Access Compliance Report

Public Rights-of-Way

(Pedestrian Signals)

Intersection ID: N/A	Main Street:	Cross Street: N/A	Location: N/A
ADA ID: 73CA3EE8917A	Signal Type: One Push Button-Non APS	Overall Compliance: No	Severity Score: BTN 1: N/A BTN 2: N/A No BTN: N/A
Codes/Mitigation Info/Possible Solution		Field Measurements/Component Compliance

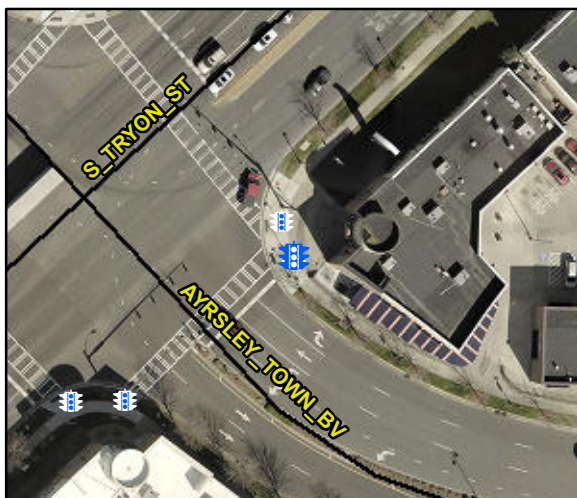
Surveyor Notes: TEXT HT 1/2, BUTTON DOES NOT WORK WHEN PRESSED

PROW/ADA: R410.6, TMUTCD 4e.08, R404.2, R404.3, R406.2, R403.4

Possible Solutions: Replace Signal Push Button With APS Button on New Post. Remove & Replace Sign.
